<b>Model</b>	SS930/950/915, Ges5130/5170/5210, Rex1060/1070/1140	<b>Volt/Hz</b>	<b>Date of Modification</b>	<b>Serial Number</b>
<b>Modified Article</b>	Upper Master Feed Roller & Upper Reverse Roller			
<b>Reason for Modification</b>	To increase the master paper feeding ability

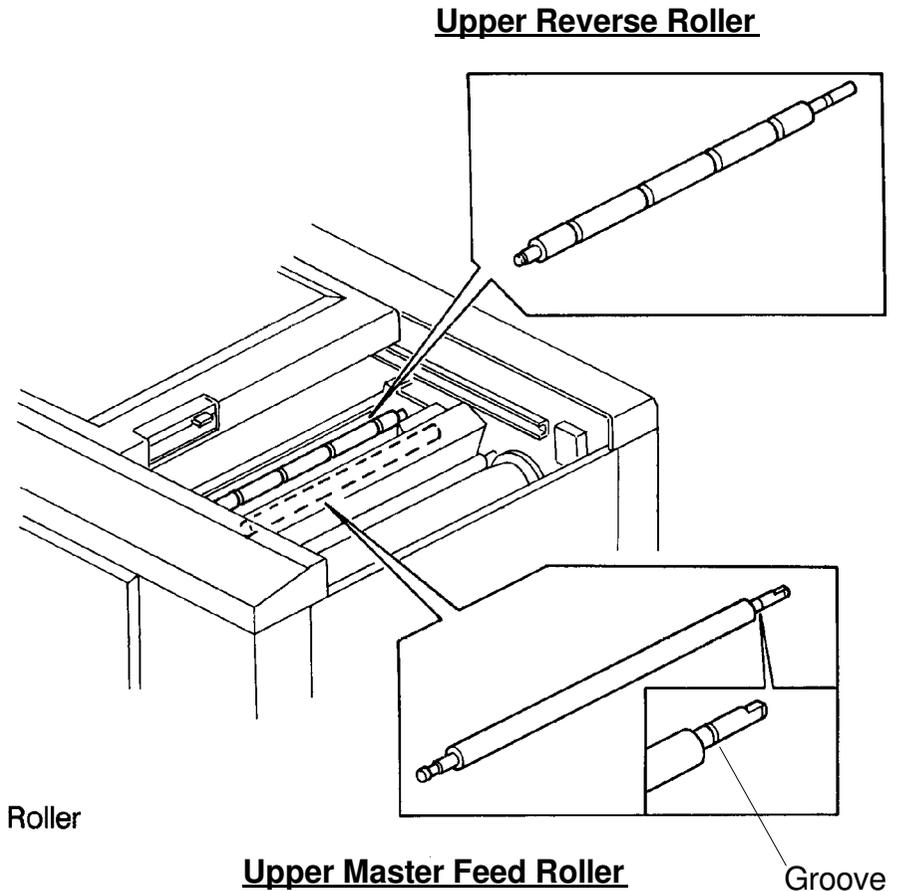
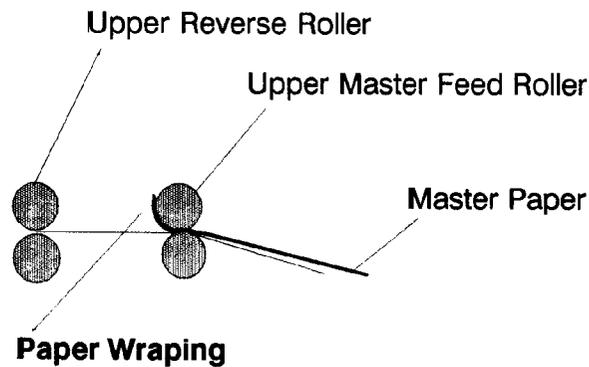
If the machine is used under extremely low humidity and temperature conditions, master paper may be wrapped around the upper master feed roller or upper reverse roller when master paper is feeding. This symptom is due to heavy static in such circumstances.

To increase the master paper feeding ability even under such circumstances, the upper master feed roller has been changed to an electrically conductive type. Also, the upper reverse roller has been changed to an anti-static type.

- NOTE: \* The color of the upper reverse roller has been changed from gray to pink.  
 \* The shaft of the new upper master feed roller has a groove for identification. (However, some of the first production rollers do not have the groove. They can be distinguished by the part number.)

**New Flat Cable (#C2018105)**

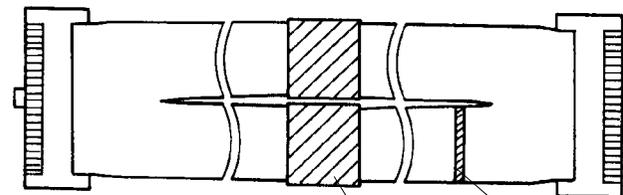
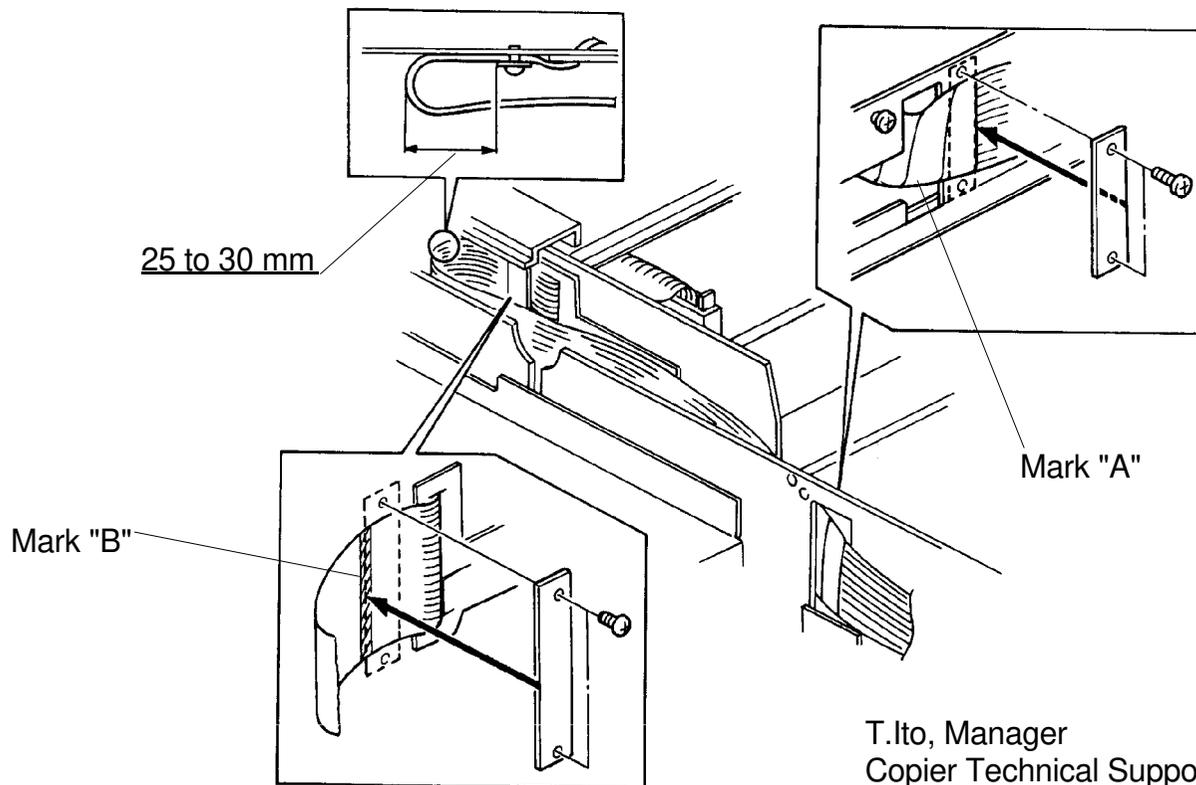
To facilitate assembly on the production line, marks ("A" and "B") have been added to the flat cable between the machine frame and scanner unit. On the production line the flat cable is assembled as shown in the illustration.

If the flat cable is not correctly installed, it may be distorted or crimped when the scanner unit is open. (To prevent the flat cable from being damaged by the edge of the frame, a strip of tape (Mark "A") has been added to the flat cable.) The flat cable is correctly positioned as shown in "FLAT CABLE POSITION" when the scanner unit is open.

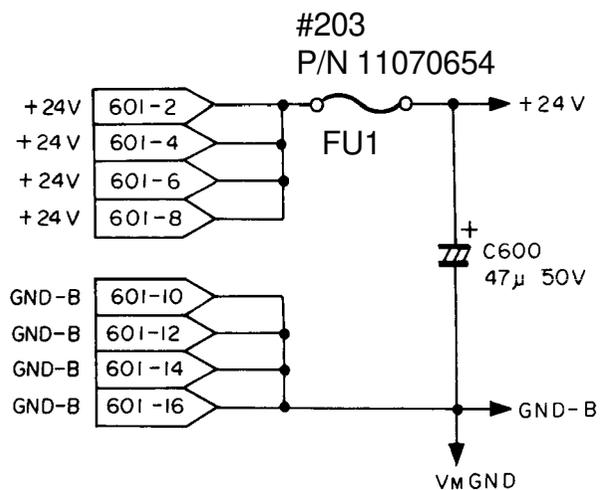
To ensure reliability of A/D conversion board, the fuse1 (P/N11070654) has been added to the main control board. And two capacitor (C609, C713) have been removed from the main control board.

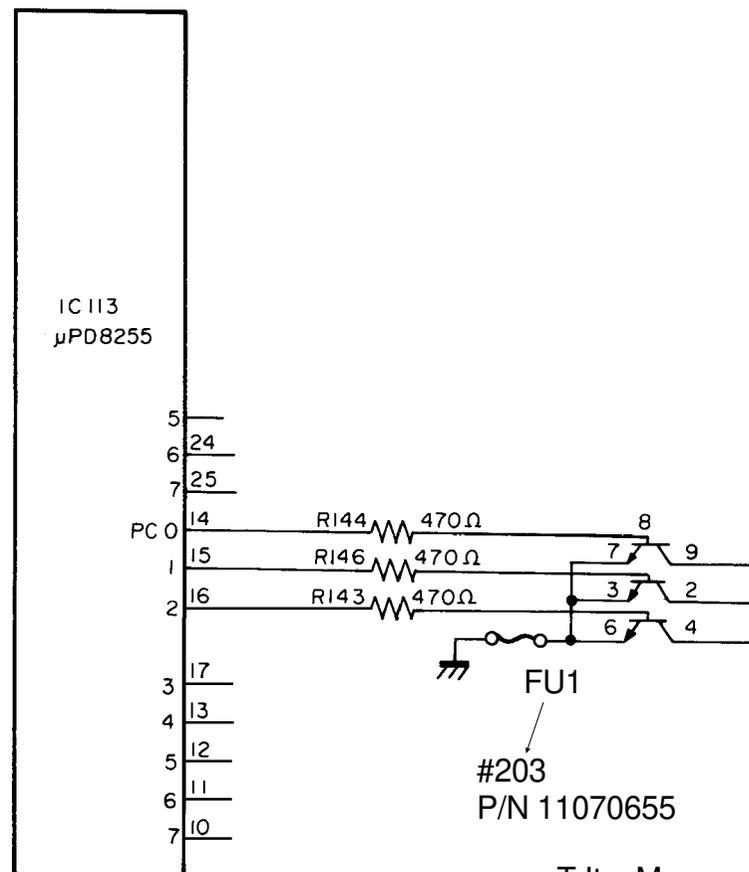
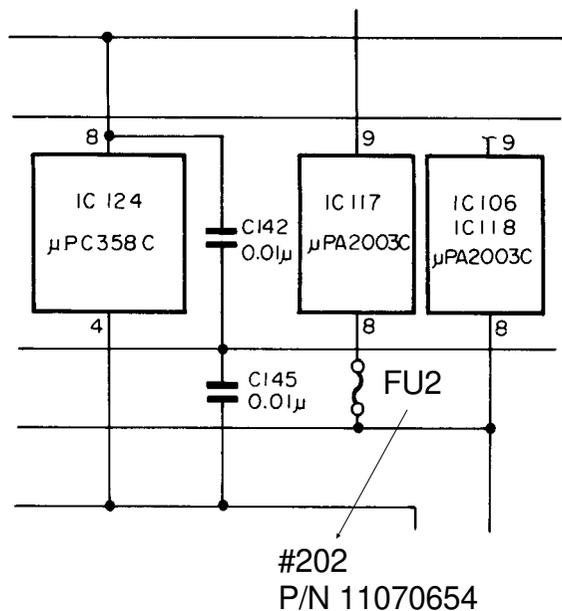
It has been reported that IC113 and IC117 were sometimes damaged due to excessive current. To ensure the reliability and durability of the main control board, the following parts have been added to the main control board.

- FU1 Newly added P/N 11070655, Index No.203
- FU2 Newly added P/N 11070654, Index No.202

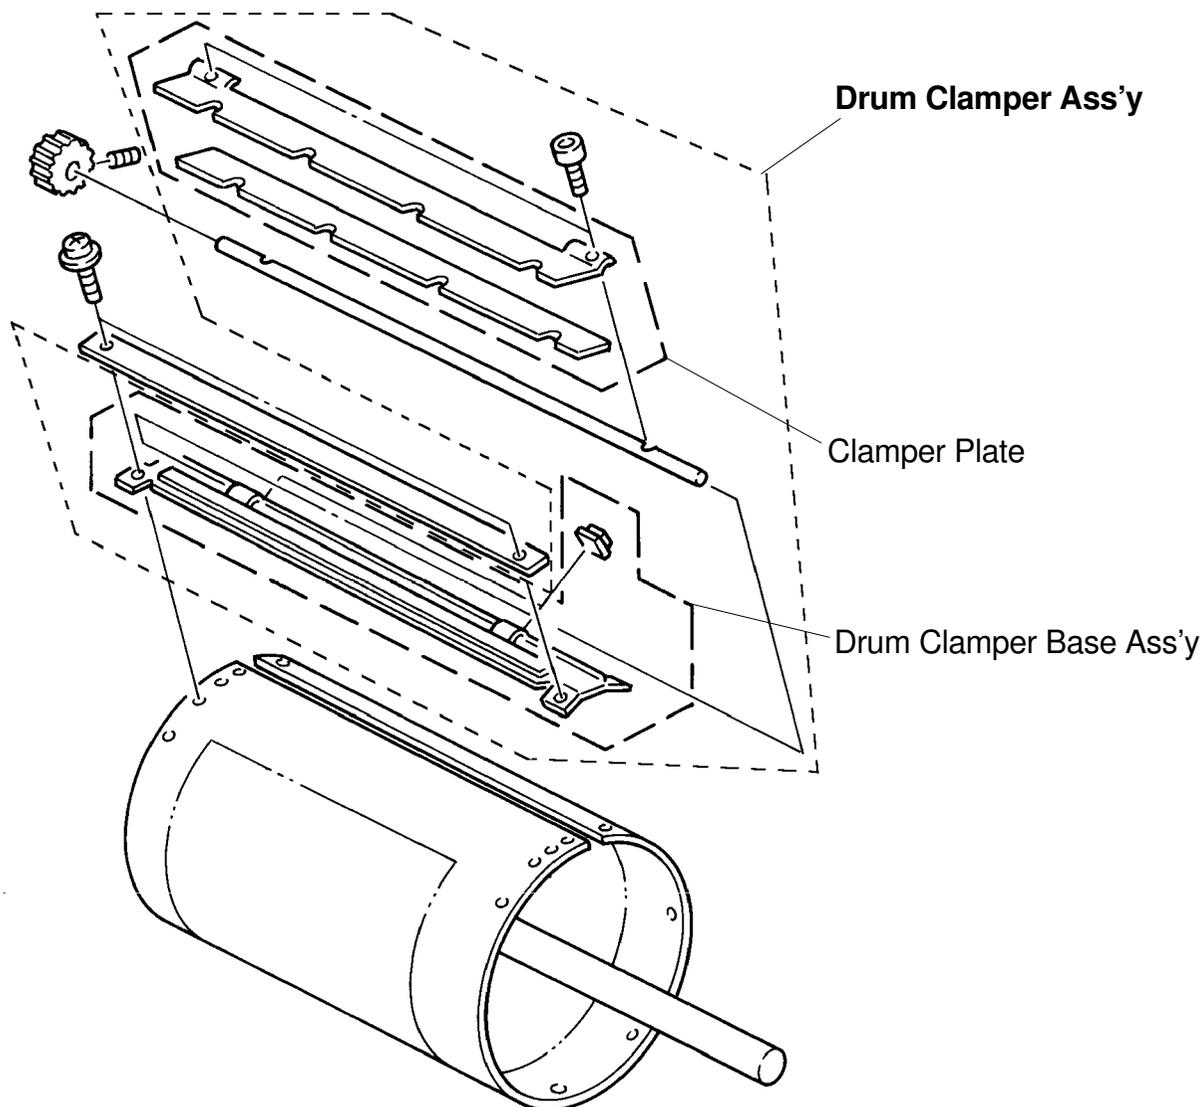
To facilitate servicing, the drum clamber ass'y has been registered as a service part. Use this assembled part when the old type clamber plate and/or drum clamber base ass'y are replaced.

**NOTE:** The difference between the drum clamber ass'y #C2034565 (for models C201, C203, C204, and C206) and #C2074948 (for models C205, C207, and C208) is the color of the base plate of the drum clamber base ass'y only. The base plate's color of #C2074948 is black to ensure the drum master detection sensor function.

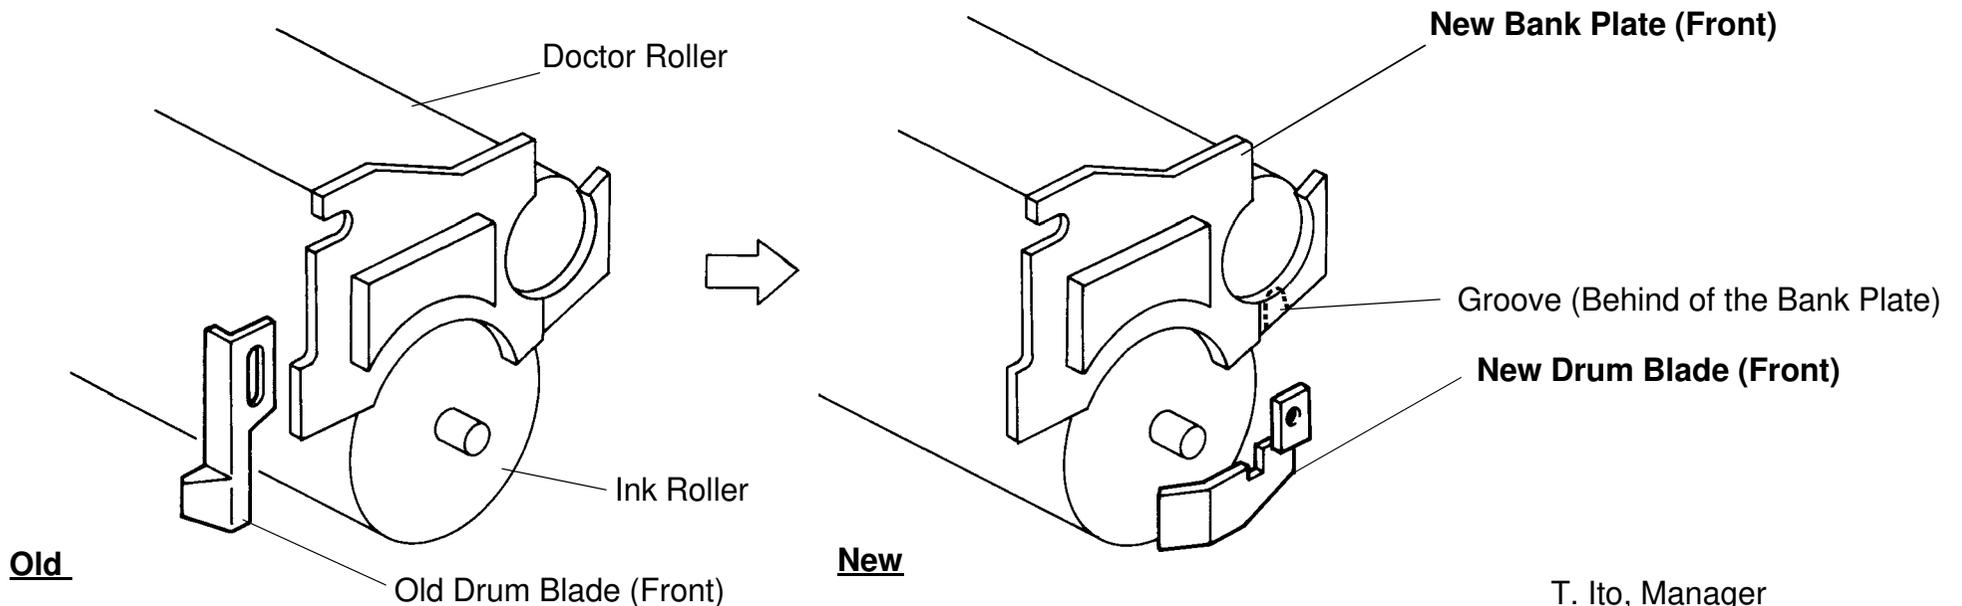
Especially when the print volume is large, ink builds-up on the ink roller edges and may transfer to inside of the drum screen and leak from the drum edges. To prevent this, the following modifications have been implemented:

1. To scrape off the built-up ink on the ink roller edges, the front and rear drum blades have been changed as shown below. (The old type drum blades scraped the inside of the drum screen.)
2. To prevent built-up ink on the ink roller edges from being scraped off by the edge of the bank plates and falling on the inside of the drum screen, a groove has been hollowed out at the edge of the front and rear bank plates.
3. To allow installation of the new drum blades, a hole has been added to the front and rear side plates of the ink roller unit (Front/Rear Side Plate - Ink Roller: Not shown in illustration).

**NOTE:** It is difficult to replace the all parts described on the first page in the field. For this reason, the drum blades kit (P/N-C2079011) has been registered as a service part. Refer to RTB No. 14 issued on January 31, 1991 for the installation procedure.

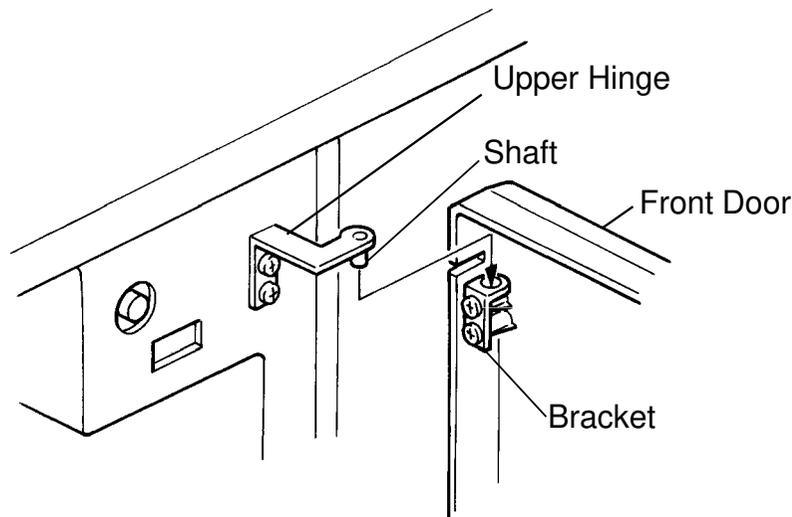
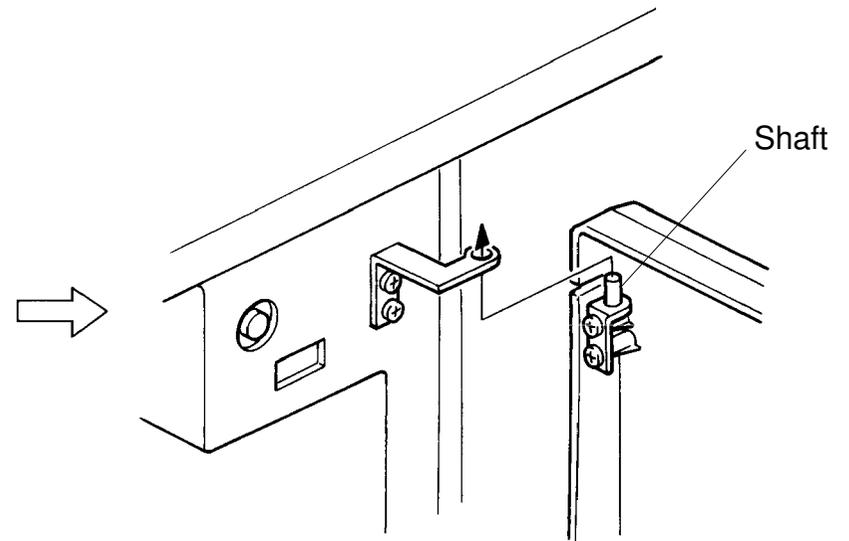
To improve durability of the front door hinges, the upper and lower hinges and the hinge brackets have been changed.

If the hinges are bent by being opened and closed roughly, the front door may get unhinged. The shaft in the hinges has been lengthened from 2.5mm to 5.9mm to prevent this. However, the shaft, which was installed in the hinges (main body side) in the old type, is now being installed in the hinge brackets (front cover side) as shown below. Therefore, there is interchangeability only as a set of the upper and lower hinges and the two brackets.

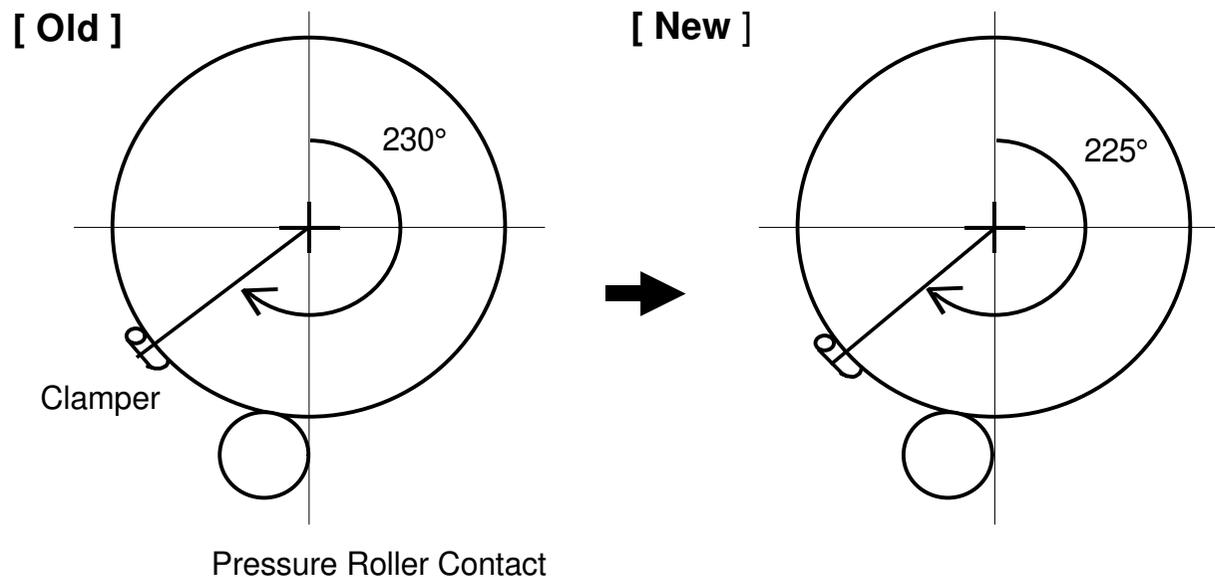
To ensure the printing quality on the leading part of the paper, the shape of the print pressure cam has been changed. If there is solid fill image on the leading part of the original and the printing speed is high (4 or 5 step), a low density horizontal band may appear about 30 millimeters from the leading edge of the print. This is caused by pressure roller bound when the pressure roller contacts the drum surface. The new print pressure cam applies the print pressure to the pressure roller 5 degrees faster in the drum rotation angle. (The pressure roller contacts the drum about 7 millimeters before the leading edge of the paper.)

NOTE: When the new print pressure cam is installed, the exit pawl timing is also changed. (The exit pawl approaches the drum 5 degrees faster in the drum rotation angle.) Therefore, it is necessary to make sure that the exit pawl does not contact the master clamber. (Readjust the exit pawl timing if necessary.)

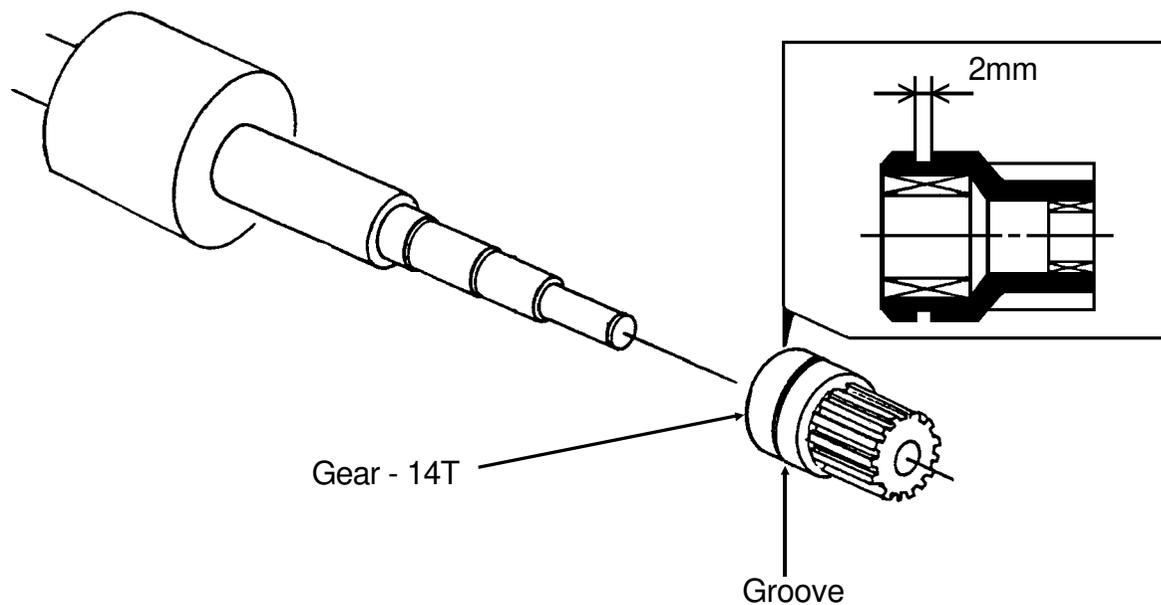
It was reported that on some machines in the field, the image position varies. Although this is a very rare case, at worst this happened after making about 200,000 prints. On the problem machine, the one-way clutch inside the 2nd feed roller gear slips just when the 2nd feed rollers start feeding a sheet. (The paper feed start timing is delayed.) This makes the image position vary, i.e. move up or down in paper feed direction. After investigation, it was found that the grease inside the one-way clutch changes in quality and damage the inside surface of the clutch. The new 2nd feed roller gear contains a new type of grease that does not change in quality unlike the old one. To distinguish the new gear from the old one, a groove is made on the new gear.

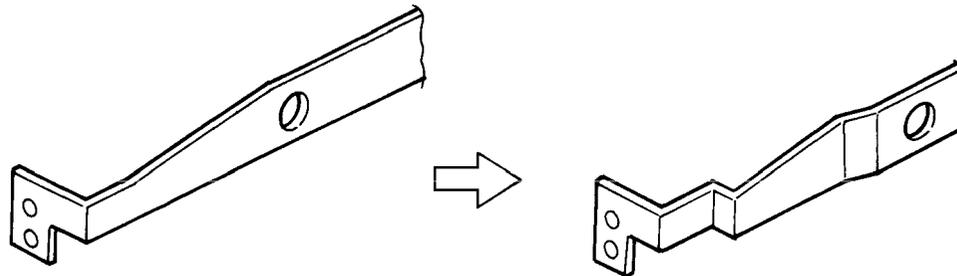
When the paper table is lowered, the feed roller arm contacts the side pad lever if the paper feed side plates are fully opened. To prevent this, the shape of the feed roller arm has been changed as shown in the illustration below.

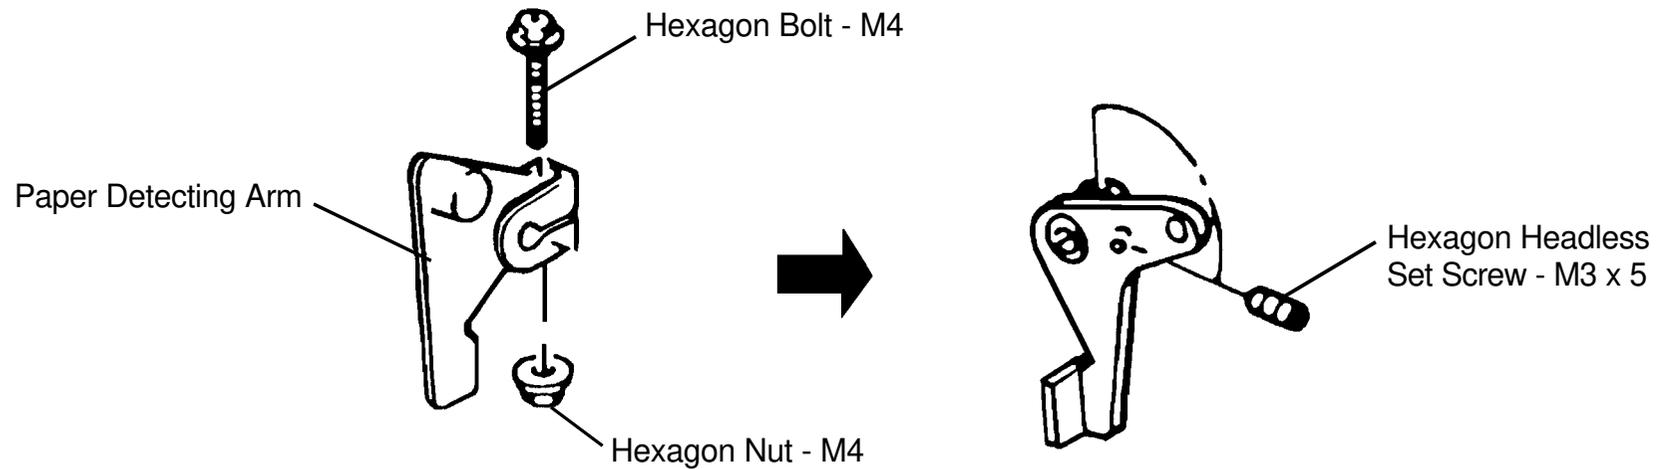
To improve strength and durability, the paper detecting arm has been changed to the type used on the NA2 (C210).
